Addendum No. 3

Subject: Major Renovation
General Construction – B-800C of 2016/17
Mechanical Construction – B-801C of 2016/17
Plumbing Construction – B-802C of 2016/17
Electrical Construction – B-803C of 2016/17

Location: Roosevelt Elementary School
430 E Washington Lane, Philadelphia, PA 19144

This Addendum, dated 29th of March, 2018, shall modify and become part of the Contract Documents for the work of this project. Any items not mentioned herein, or affected by, shall be performed strictly in accordance with the original documents.

Drawing No.:
SK-2A

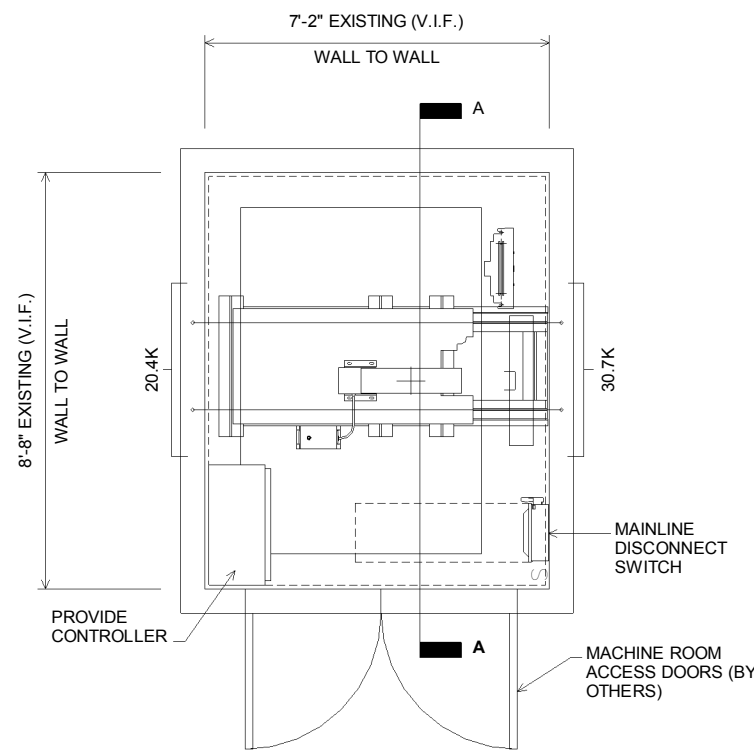
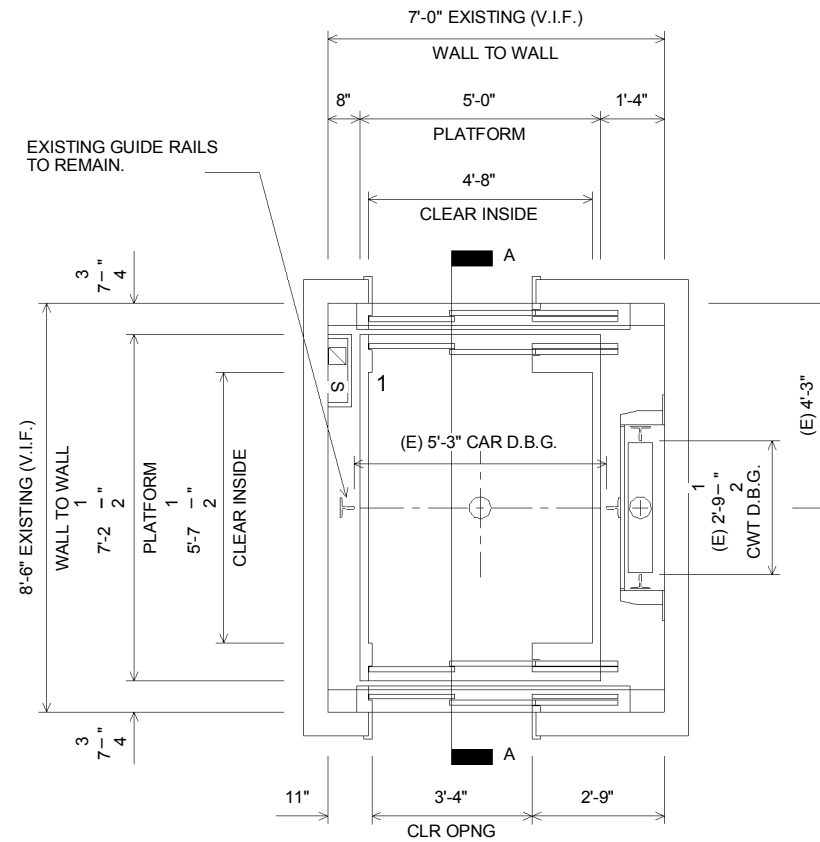
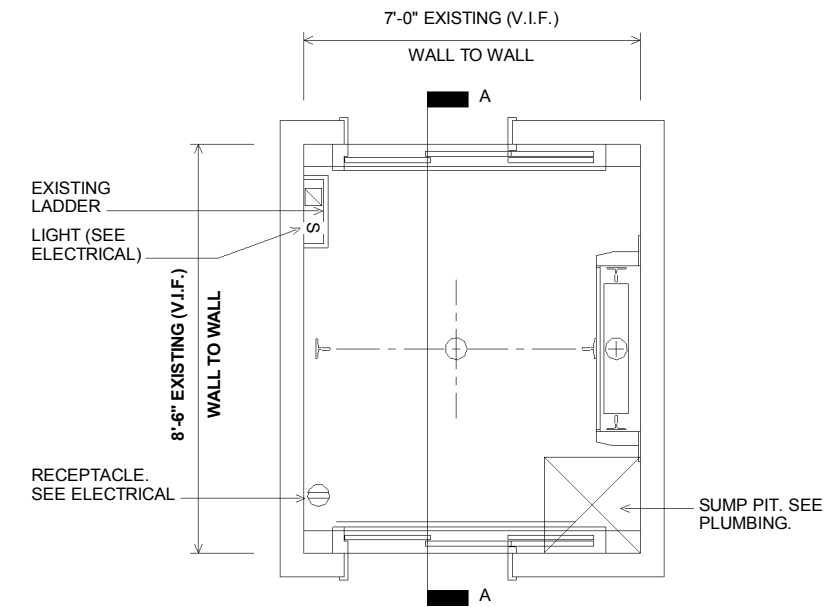
Elevator Drawings SK-2A and SK-2B (copies attached) have been added to the scope of the project.
